**WSR 22-17-148**  
**PROPOSED RULES**  
**BUILDING CODE COUNCIL**  
 [Filed August 23, 2022, 4:00 p.m.]

Title of Rule and Other Identifying Information: Chapter 51-51 WAC, Adoption and amendment of the 2021 International Residential Code.

**STATE BUILDING CODE ADOPTION AND AMENDMENT OF THE ((2018)) 2021 EDITION OF THE INTERNATIONAL RESIDENTIAL CODE**

Figure R403.1.1(1)  
 Alternative Minimum Footing Size for Light-Frame Construction  
 a, b, c, d, e, f, g, h, i  
 20 PSF Snow Load

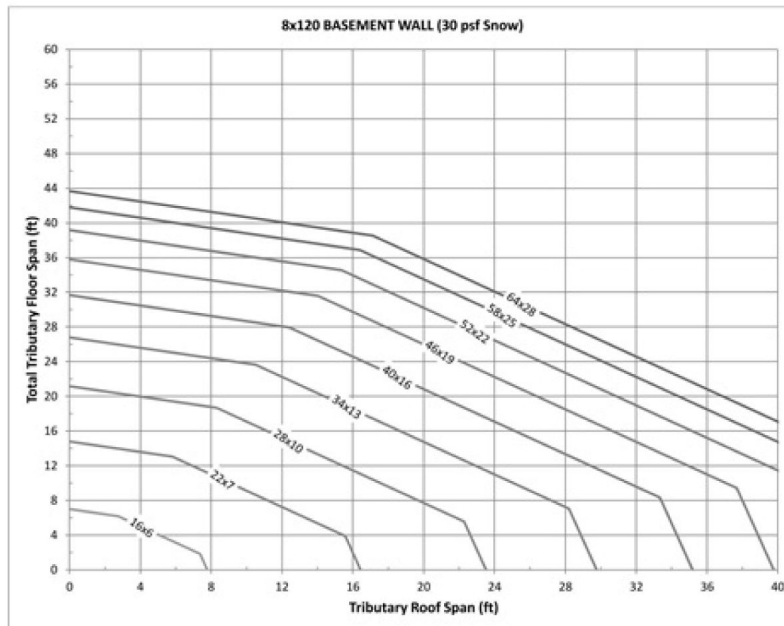
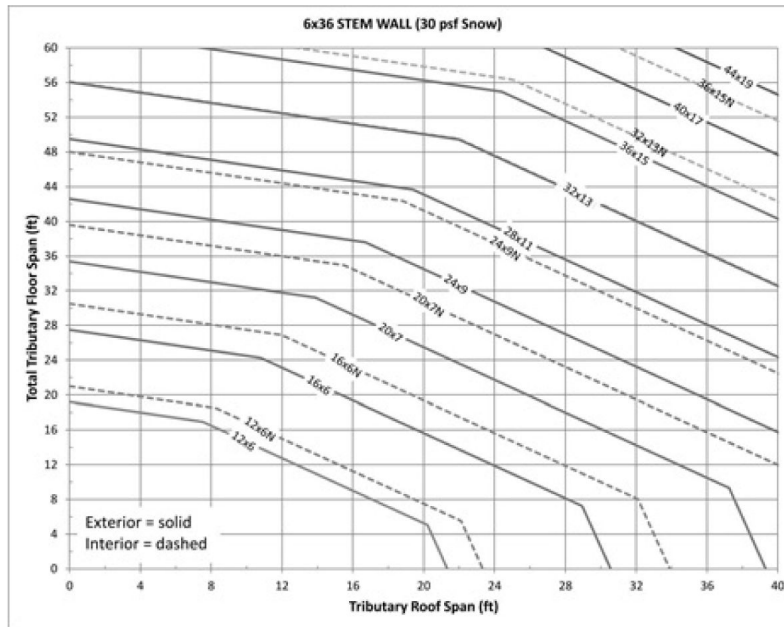
**R403.1.1 Minimum size.** The minimum width,  $W$ , and thickness,  $T$ , for concrete footings shall be in accordance with Tables R403.1(1) through R403.1(3) and Figure R403.1(1) or R403.1.3, as applicable, but not less than 12 inches (305 mm) in width and 6 inches (152 mm) in depth. The footing width shall be based on the load-bearing value of the soil in accordance with Table R401.4.1. Footing projections,  $P$ , shall be not less than 2 inches (51 mm) and shall not exceed the thickness of the footing. Footing thickness and projection for fireplaces shall be in accordance with Section R1001. The size of footings supporting piers and columns shall be based on the tributary load and allowable soil pressure in accordance with Table R401.4.1. Footings for wood foundations shall be in accordance with the details set forth in Section R403.2, and Figures R403.1(2) and R403.1(3). Footings for precast foundation shall be in accordance with the details set forth in Section R403.4, Table R403.4, and Figures R403.4(1) and R403.4(2).

EXCEPTION: Light-frame construction shall be permitted to have minimum footing size in accordance with Figures R403.1.1(1) through R403.1.1(4) in lieu of that determined by Table R403.1(1).

Figure R403.1.1(2)  
 Alternative Minimum Footing Size for Light-Frame Construction  
 a, b, c, d, e, f, g, h, i  
 30 PSF Snow Load

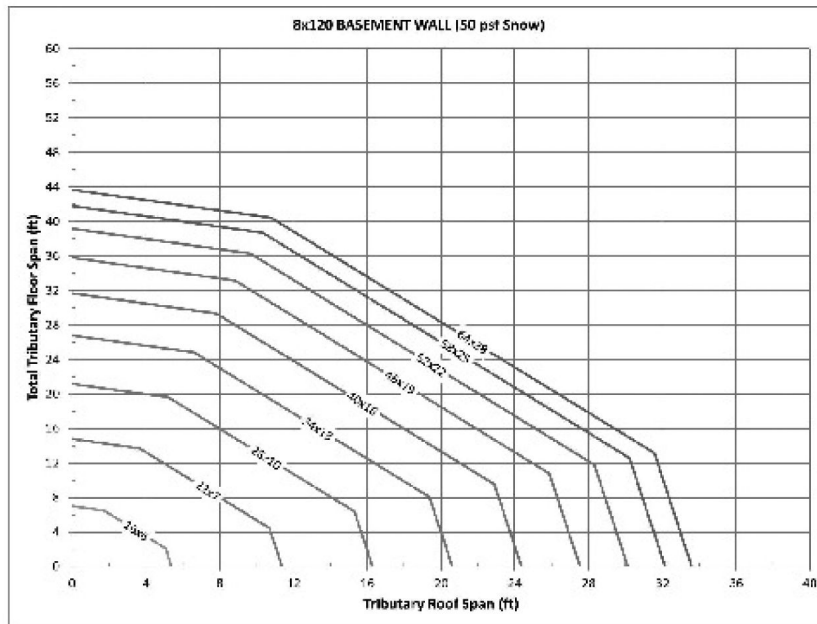
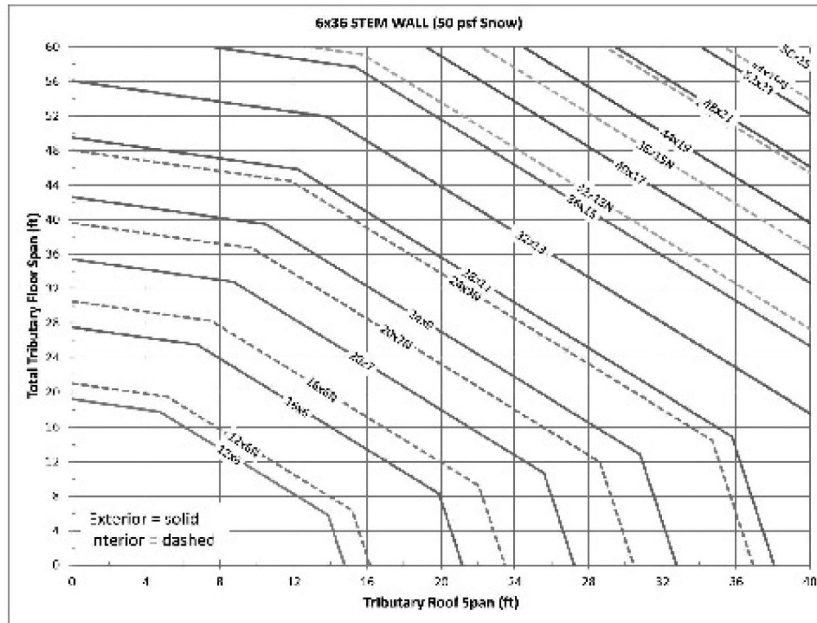
- Notes:
- a The minimum footing size is based on the following assumptions: Material weights per Section R301.2.2.1 and soil density = 120 pcf. Wood framed walls = 10 foot; crawlspace stem wall = 6 inches × 36 inches; basement wall = 8 inches × 120 inches. Total load (TL) equal to the maximum of three load combinations: LC1=D+L, LC2=D+S and LC3=D=0.75(L+S), where D=dead load, L=live load, S=snow load. TL=max(LC1, LC2, LC3).

- b Use tributary span of floor and roof. Figure may be used to size exterior and interior footings.
  - c Add 4 feet to tributary floor span for each wood framed wall above first level (i.e., 4' for 2-story, 8' for 3-story).

Figure R403.1.1(3)  
 Alternative Minimum Footing Size for Light-Frame Construction  
 a, b, c, d, e, f, g, h, i  
 50 PSF Snow Load

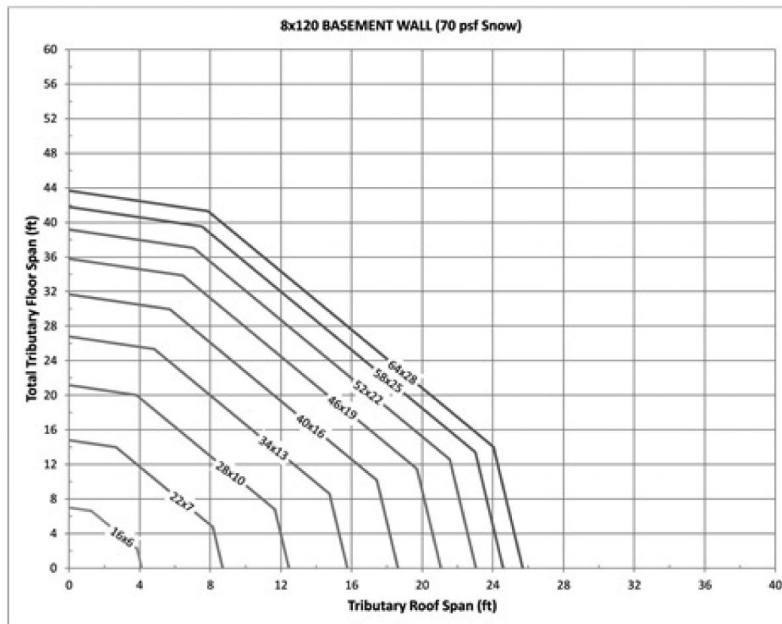
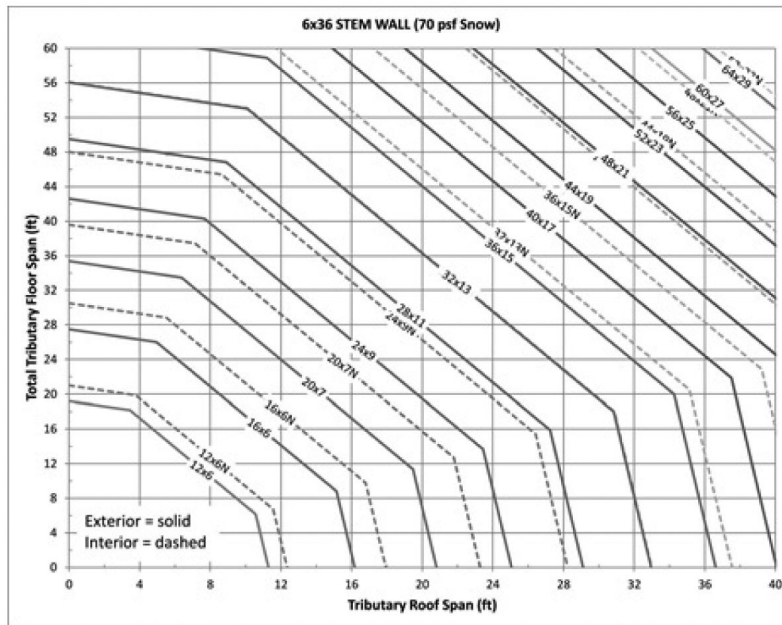
- Notes:
- a The minimum footing size is based on the following assumptions: Material weights per Section R301.2.2.1 and soil density = 120 pcf. Wood framed walls = 10 foot; crawspace stem wall = 6 inches × 36 inches; basement wall = 8 inches × 120 inches. Total load (TL) equal to the maximum of three load combinations: LC1=D+L, LC2=D+S and LC3=D+0.75(L+S), where D=dead load, L=live load, S=snow load. TL=max(LC1, LC2, LC3).

- b Use tributary span of floor and roof. Figure may be used to size exterior and interior footings.
  - c Add 4 feet to tributary floor span for each wood framed wall above first level (i.e., 4' for 2-story, 8' for 3-story).
